Bag Carrier CHANGELOG

Version 2.0 | 2022-Feb-02

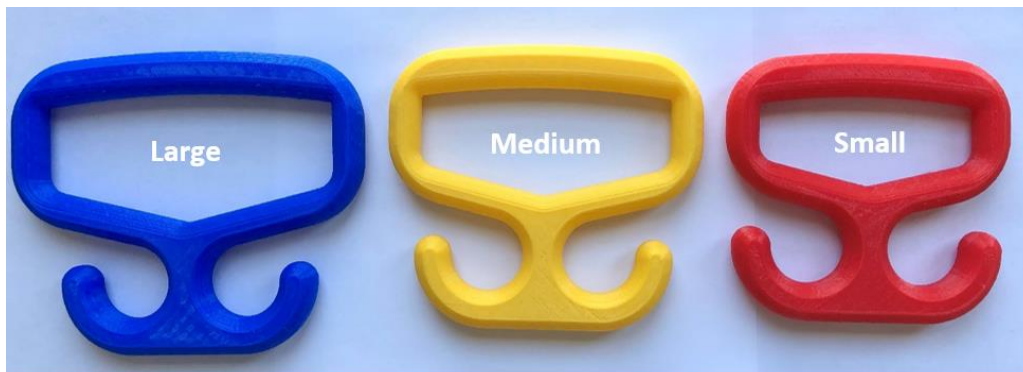
This is a newly designed handle to replace the old one.

- Significantly reduced print time
- Designed 3 different sized handles to better accommodate different sized hands. The width and the height of the handle hole increases for the larger sized handles.
- Made the handle less bulky.
- Increased the strength per gram of the handle by connecting the two hooks.

This bag carrier was very strong, but ultimately replaced as the print time was much too long, and the handle was quite bulky.
